2.3.1 AMENDMENT 11: CPL

Lift 06 extended to serve L02

1 Approved massing

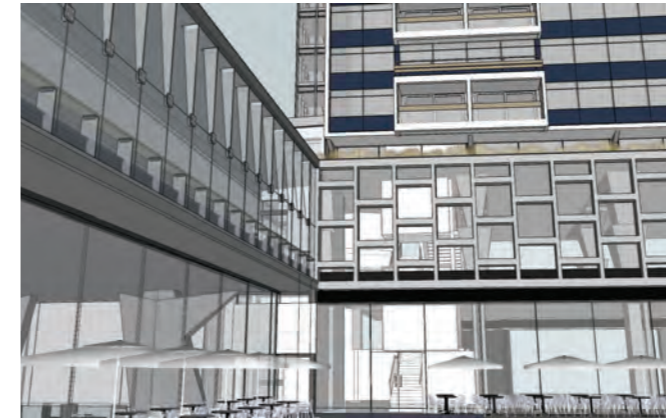
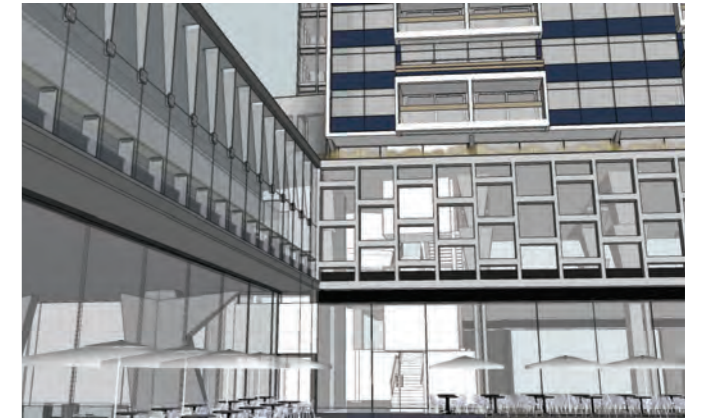
LOCATION OF PARTIALLY VISBLE OVERRUN VIEWS FROM PUBLIC SQUARE

350mm reduction to form separation from existing CPL roof line

LIFT ENCLOSURE WIDTH REDUCED TO ENSURE CLEARLY DEFINED SEPARATION FROM CPL ROOF
